Proposed Amendment to the Order Amending Water Quality Monitoring Plan issued April 23, 2012

# Caldron Falls Hydroelectric Project (FERC No. 2525)

## Proposed Amendments to the Approved Water Quality Monitoring Plan

DATE: March 12, 2013 FILE REF: WPS Caldron Falls P-2525  
TO: Wisconsin Public Service  
FROM: WDNR  
SUBJECT: WDNR Comments to the 2011 Water Quality Monitoring Summary and Monitoring Plan Amendment Request

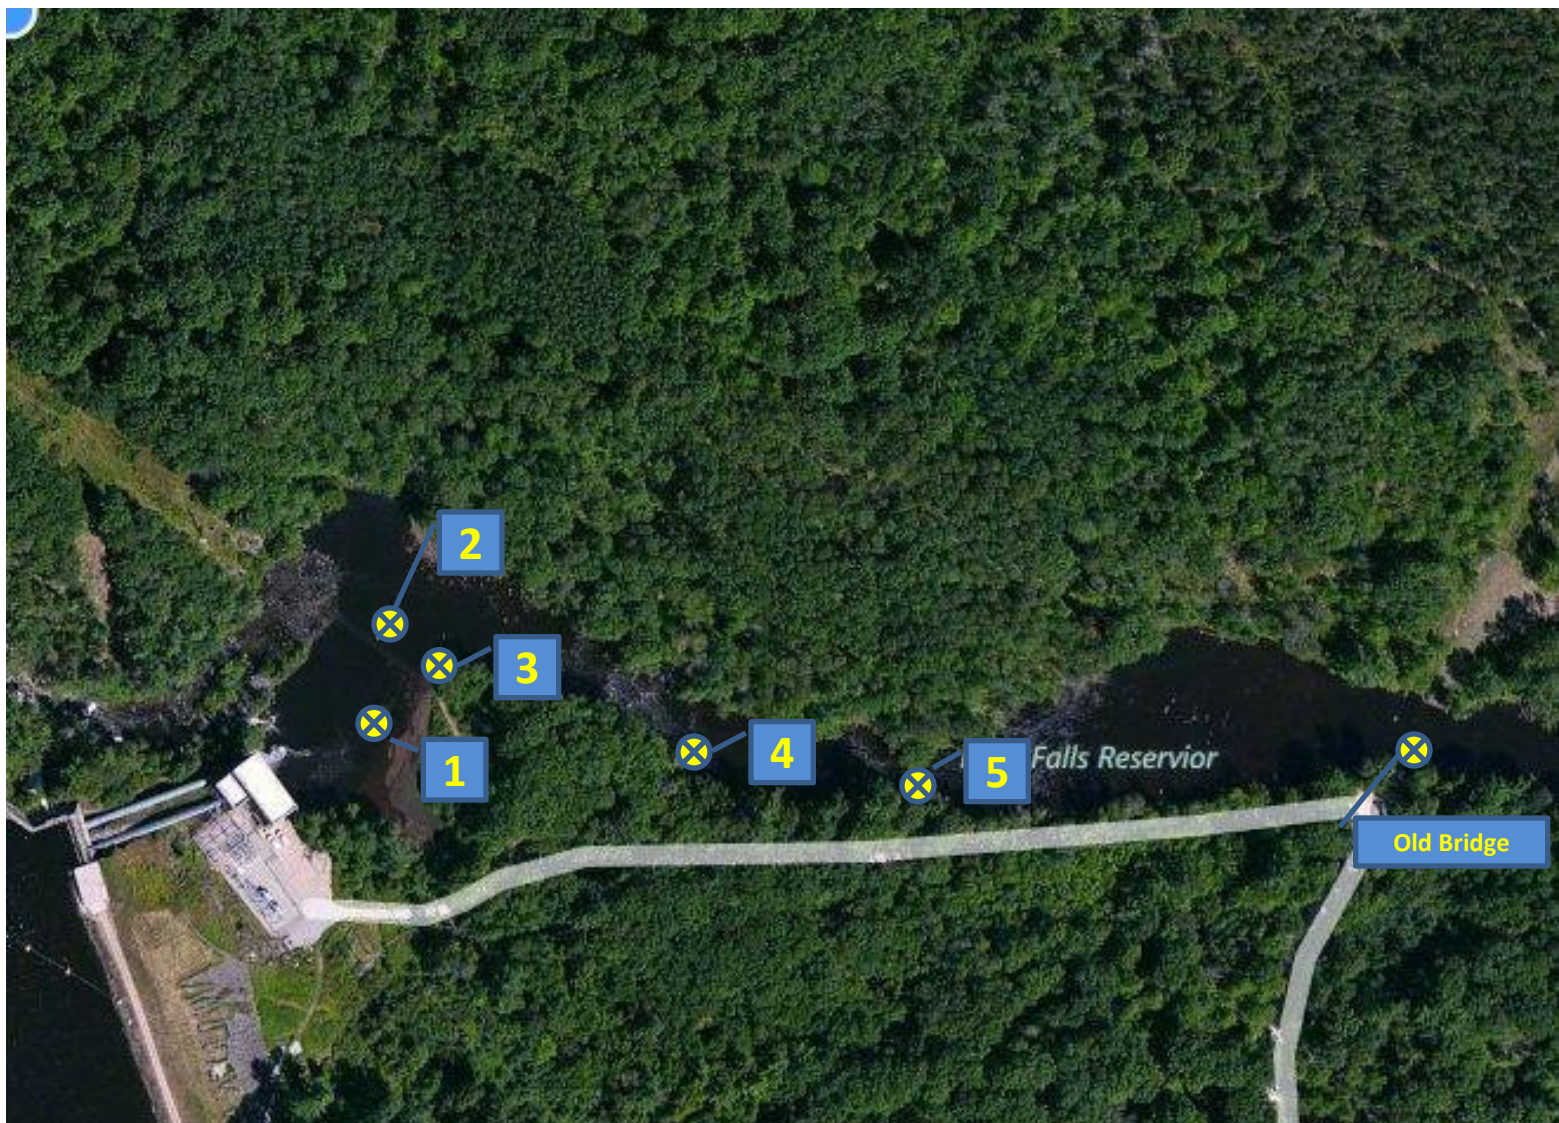
2. Monitoring for pH should be continued at the downstream monitoring location.
3. Based on the joint site visit during the 2012 field season, a downstream sample location could be moved and located to the area closer to location #5 on the attached map. The previous sample location was located approximately 600 ft downstream of the dam. The new sample location would be approximately 900 feet downstream of the dam where sufficient water depth and access is available for the sample equipment to remain submerged during refill peaking operations.

**Response:** The monitoring plan has been amended as follows: Monitoring downstream of the Project shall occur approximately 770' downstream of the powerhouse in a location that is unaffected by changes in water elevation due to fluctuations in release flow volumes (NW ¼ of NE ¼, T33N, R18E, Section 10, approximately at 88° 13' 39.9"N, 45° 21' 25.7"W).
